**VIA ELECTRONIC FILING**

May 13, 2024

Re: Comments on the Environmental Assessment for Application to Surrender License for the Newhalem Creek Hydroelectric Project (P-2705-037)

Figure 1. From left to right: the powerhouse, penstock, adit containing the penstock, concrete plug, power tunnel, vertical shaft, intake, and dam.

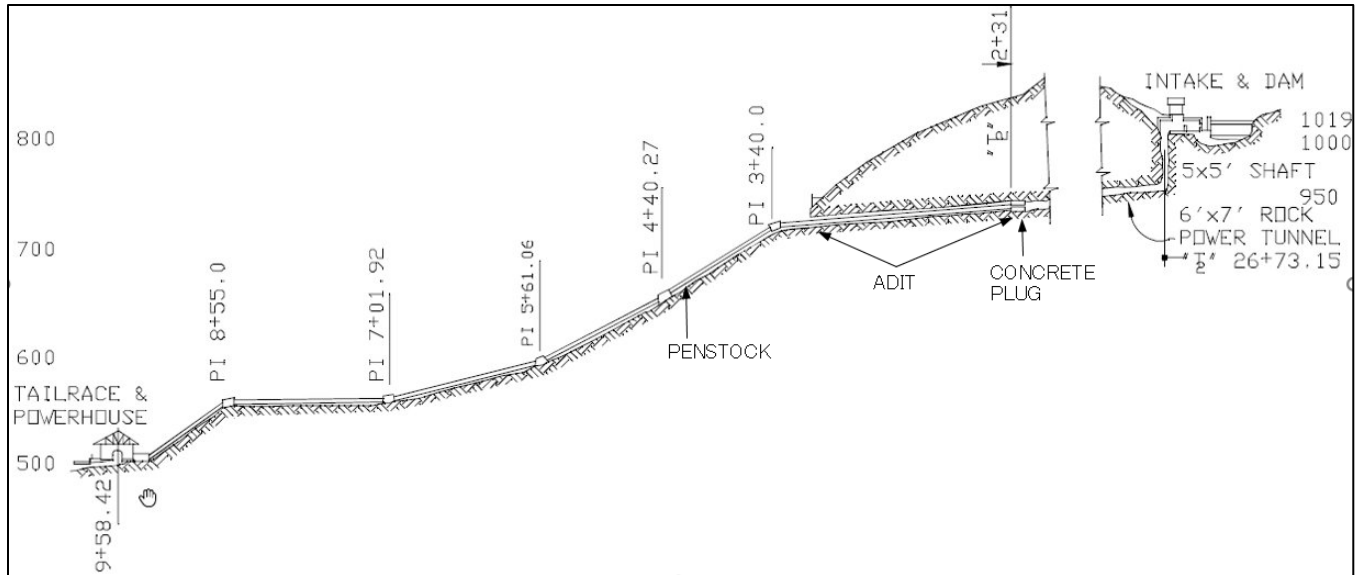
The EA states that "Retaining access to the power tunnel for bats or other small wildlife would require City Light to transport the 50 cubic yards of debris that it proposes to use to seal the upper end of the tunnel off-site, which would require an additional 16 haul trips and add a day to the debris removal process."

The Surrender of License Application provided that approximately 50 cubic yards of concrete from dam removal could potentially be disposed in the vertical shaft portion of the power tunnel (see Figure 1). Since the vertical shaft is adjacent to the dam, this would reduce truck trips offsite by 15 trips, minimizing impacts on recreation and wildlife. After discarding the construction debris into the vertical shaft, the opening into the vertical shaft would be sealed with fresh concrete atop the concrete rubble, creating a seal to prevent water from entering the shaft. The vertical shaft is not currently accessible to wildlife (including bats) as it is blocked by the intake gate on the upper end and a concrete plug at the lower end, as shown in Figure 1. Bats and other wildlife do currently have access to the lower end of the more-or-less-horizontal adit where it daylights, as shown in Figure 1. No concrete would be placed in the adit or any areas presently accessible to wildlife. The concrete plug currently prevents wildlife access to the power tunnel and shaft and would continue to do so after decommissioning. Thus, the current proposal to place 50 cubic yards of concrete into the vertical shaft, seal the intake, and install a gate on the lower end of the adit would limit truck trips and ensure that all access currently available to smaller wildlife is continued after decommissioning.

Figure 2. Excerpt from Upper Skagit, Newhalem Area map in Williams and Phinney (1975) illustrating impassable fish barriers at RM 0.65 and 1.0.

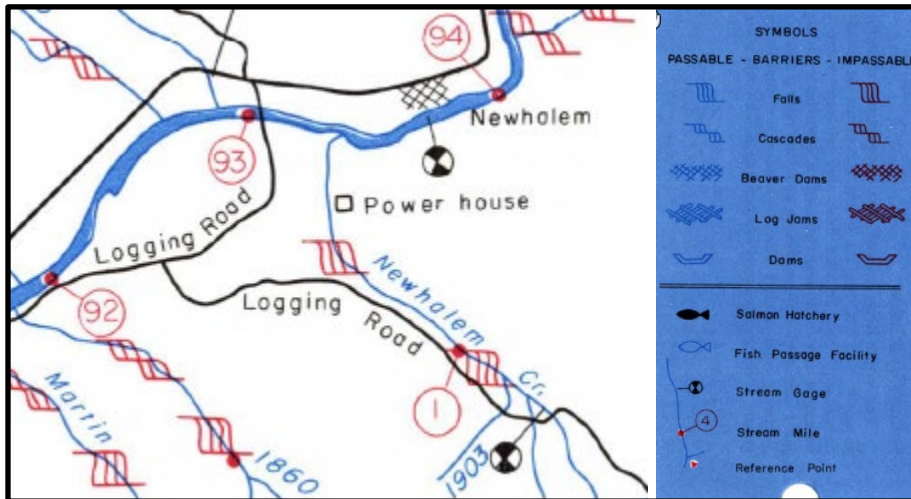
- In *Section 6.3.4.1 Affected Environment / Essential Fish Habitat (EFH)*, the EA states, “City Light believes that the presence of two natural waterfalls that are impassable to fish preclude EFH in Newhalem Creek upstream of RM 0.65.” City Light would like to add that these barriers are identified in *A Catalog of Washington Streams and Salmon Utilization* (Williams and Phinney 1975). An excerpt of the fish barrier map from Williams and Phinney (1975) is provided in Figure 2 below.
